CPED STAFF REPORT

Prepared for the Heritage Preservation Commission
 HPC Agenda Item #1
 December 15, 2015
 BZH-28948

Property Location: 401 1st Avenue North
Project Name: 401 1st Avenue North Rehabilitation
Prepared By: Chris Vrchota, Senior City Planner, (612) 673-5467
Applicant: 401 Ventures LLC
Project Contact: Amy Meller, MacDonald & Mack Architects
Ward: 3
Neighborhood: Downtown West
Request: To rehabilitate the existing building.
Required Applications:

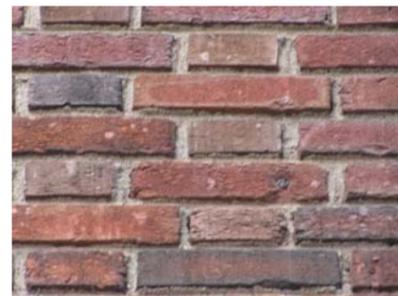
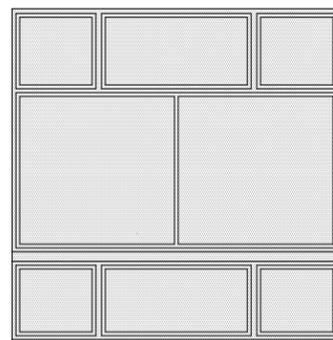
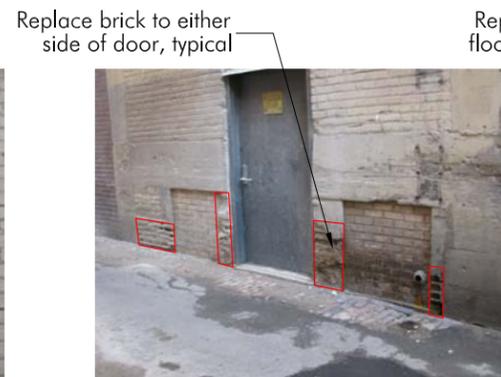
Staff Comment: The applicant is proposing to repoint the entire building, using mortar matching the historic mortar in terms of color, texture, tooling and appearance. This portion of the proposed work meets the design guidelines. They are proposing the use of mechanical tools (pneumatically powered chisels and saws) along with hand tools, which is not in keeping with the design guidelines. The project manual submitted by the applicant calls for mock ups of the proposed work to be completed and reviewed prior to the start of work, and for the work to be supervised by the architect throughout the project to ensure that historic building materials are not damaged. Other projects have been allowed to proceed using mechanical tools when

supervised by a professional who specializes in the treatment of historic properties. Staff recommends that mechanical tools only be allowed for removal of horizontal joints, with vertical joints only being cleared by hand. Staff believes that this condition, along with the proposed oversight of the work should protect the historic building materials while allowing the repointing to be completed in a timely and efficient manner.

1. By ordinance, approvals are valid for a period of two years from the date of the decision unless required permits are obtained and the action approved is substantially begun and proceeds in a continuous basis toward completion. Upon written request and for good cause, the planning director may grant up to a one year extension if the request is made in writing no later than December 15, 2017.
2. By ordinance, all approvals granted in this certificate of appropriateness shall remain in effect as long as all of the conditions and guarantees of such approvals are observed. Failure to comply with such conditions and guarantees shall constitute a violation of this Certificate of Appropriateness and may result in termination of the approval.
3. Mechanical tools shall only be used to clear horizontal mortar joints. Vertical mortar joints shall only be cleared using hand tools.

4 | Existing Building Window Key
 A201 | 1/16"=1'-0"

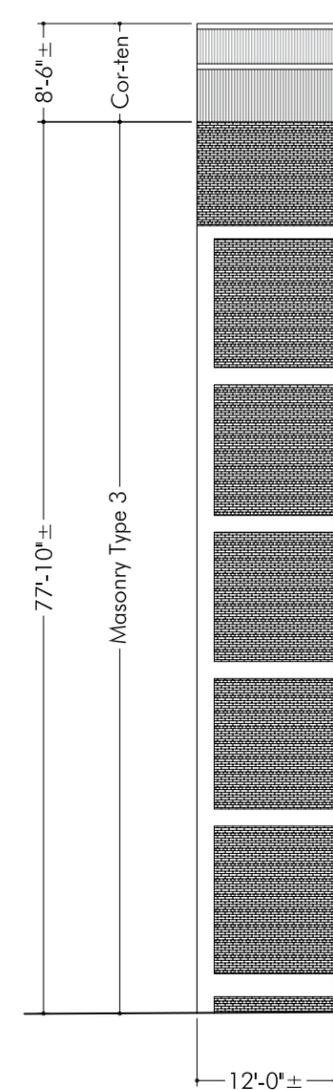
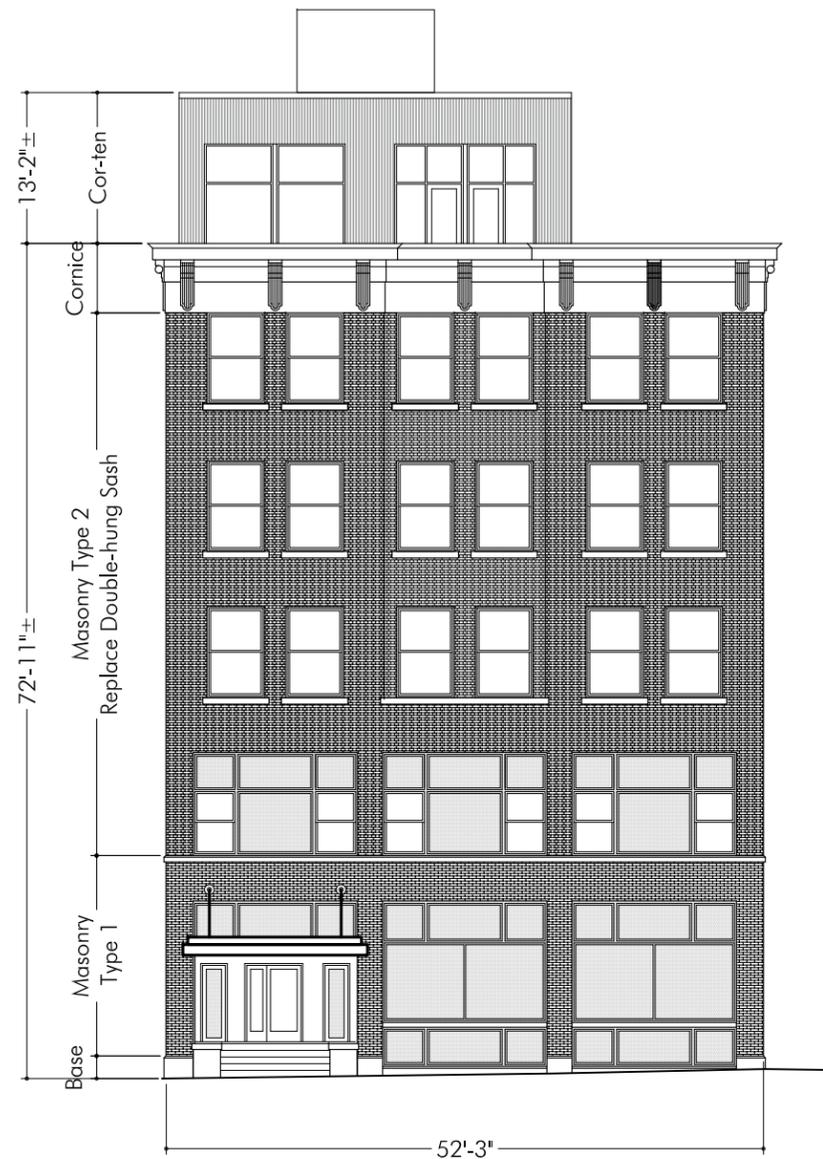
The applicant is proposing to replace all of the existing non-historic double-hung windows on the building within the existing openings and retaining the existing frames. The new proposed windows would be fixed, but the lower sash would be inset to retain the appearance of a traditional double-hung window. The proposed replacement windows are aluminum with clear glass, matching the existing, and would match the existing window dimensions. The proposed replacement meets the requirements and intent of the design guidelines.

5 | Replace Brick on South Elev.
A202 | NTS

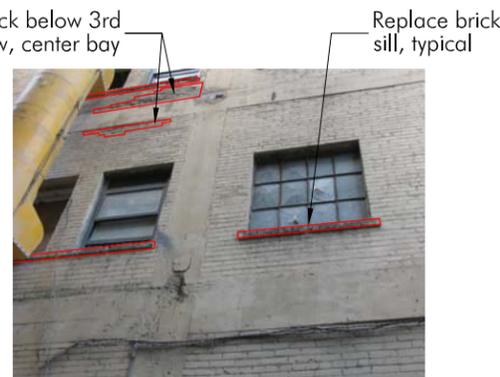
Staff Comment: The applicant is proposing to replace cracked, spalled, and otherwise damaged masonry units on the wall and sills at the rear (south) elevation of the building. The applicant has stated that the replacement brick will match the existing in size, shape, color, color variation within units, and surface texture. The project manual calls for a mockup of replacement work to be completed for review by the architect prior to the start of the full-scale scope of work. This proposal meets the requirements of the guidelines.

6th Floor Exterior
Elevations; Details

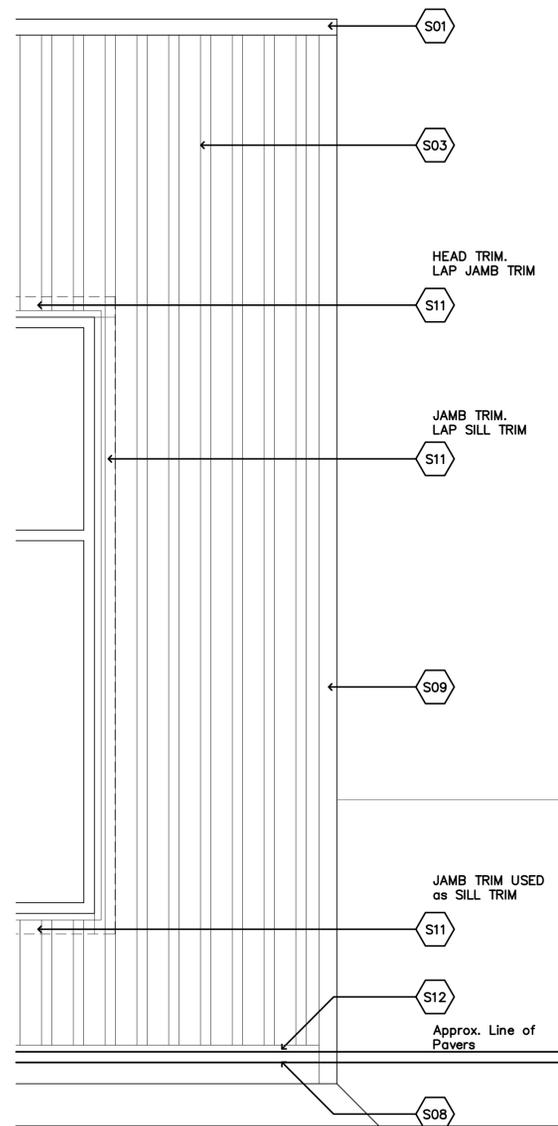
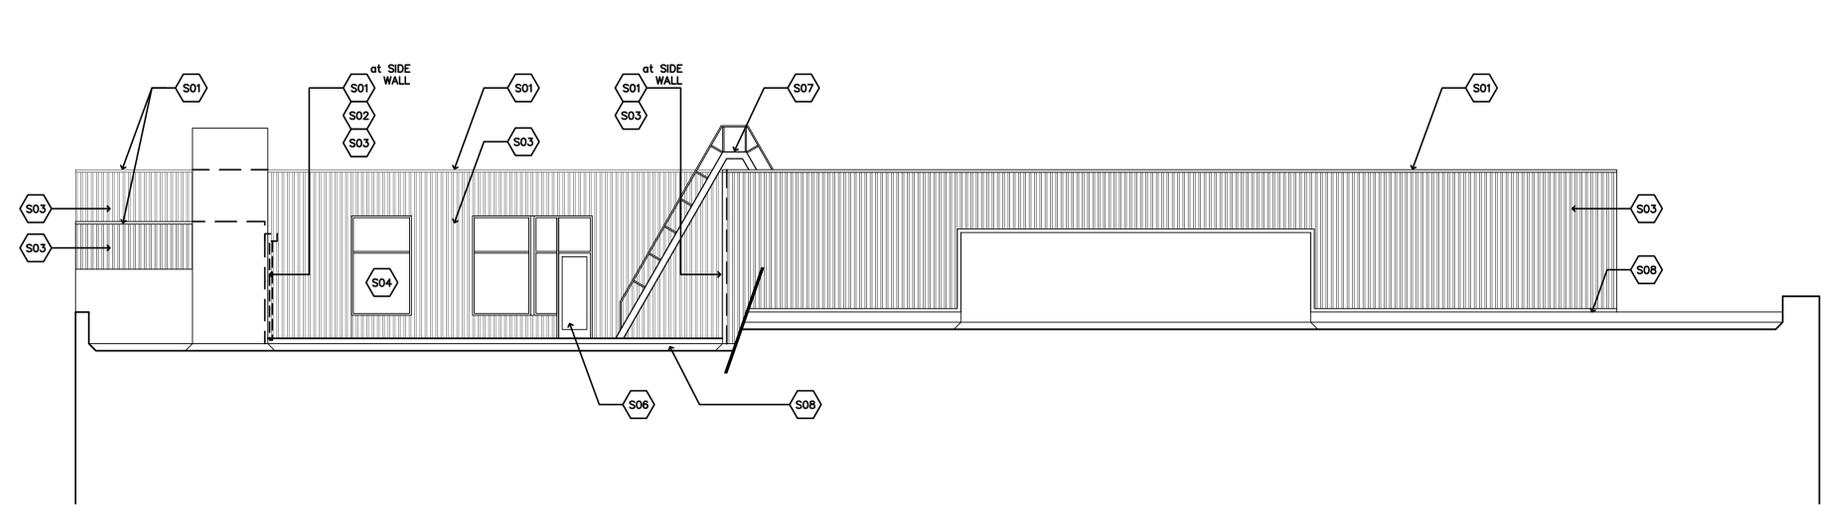
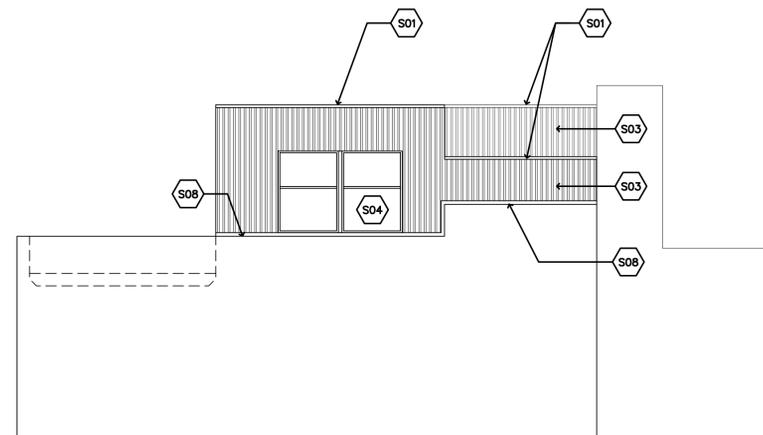
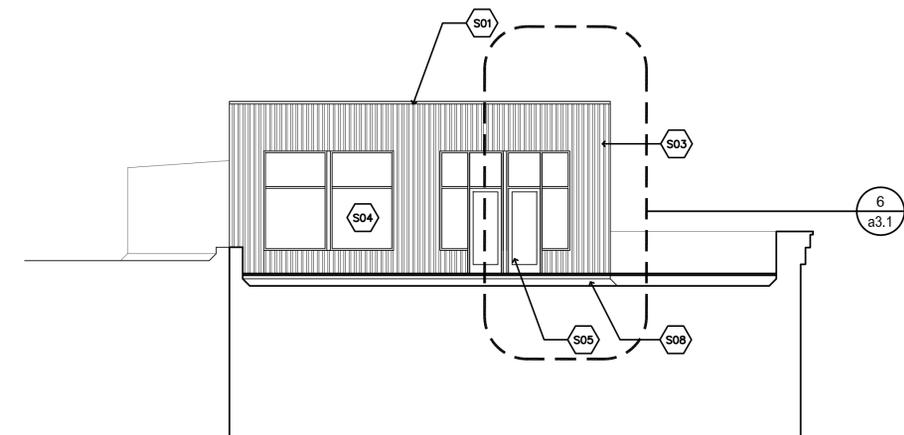
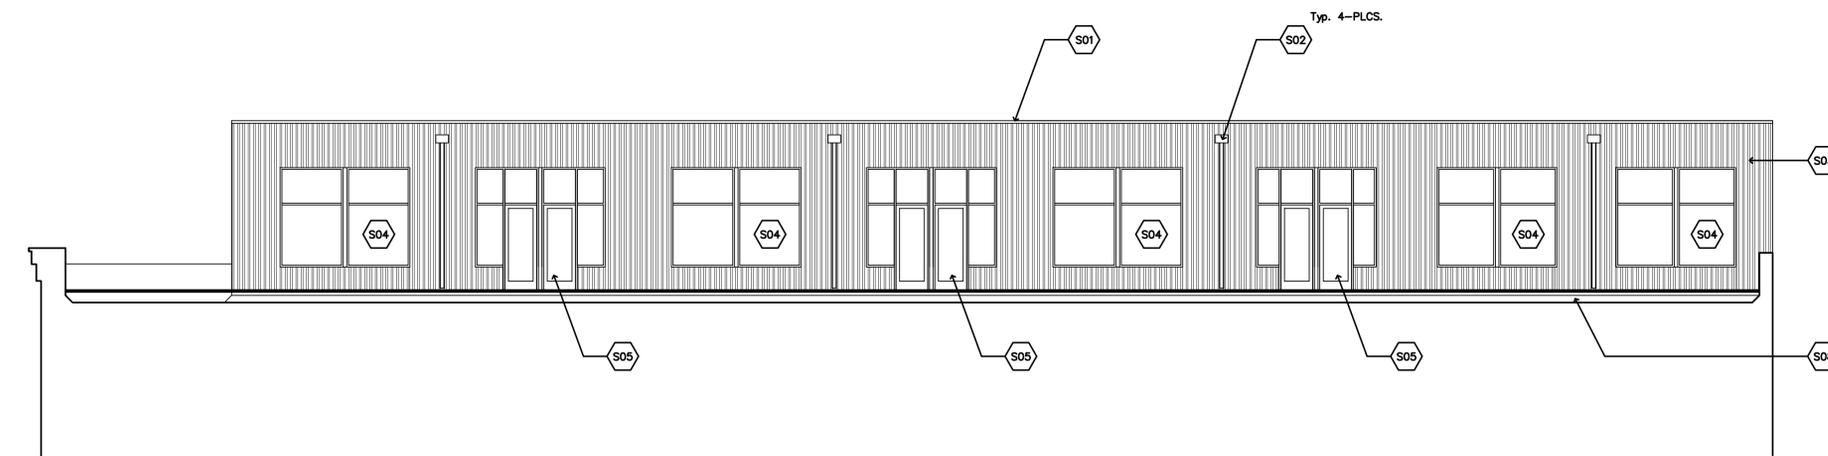
Staff Comment: The original design approved by the HPC for the rooftop addition called for the addition to be clad in weathered steel panels. The applicant is now proposing to use Cor-Ten steel siding to finish the rooftop addition, going back to the originally approved material. Exposed metal siding fits with the industrial warehouse character of the Warehouse Historic District. It is compatible with the character of the building and district, while being distinctly different from the brick used for the construction of the historic portion of the building. The proposal meets the intent and requirements of the guidelines.

Staff Comment: The *Minneapolis Warehouse Historic District Design Guidelines* have been substantially updated since the original approval for the rooftop addition in 2008. The original approval met the design guidelines in effect at that time. The new design guidelines provide somewhat contradictory guidance on the use of exposed metal, with the requirement section stating that such materials shall not be allowed, while the other considerations section states that they will be considered.

- REVISE EXTERIOR CLADDING MATERIAL from THIN-VENEER BRICK to A606 'COR-TEN' STEEL CORRUGATED SIDING (vertical installation) .
- REVISE DOORS to PAIRED 36" wide UNITS; PROVIDE (4) PAIR.
- EXTEND AREA of PC CONC. PAVERS to COVER ENTIRE ROOF.
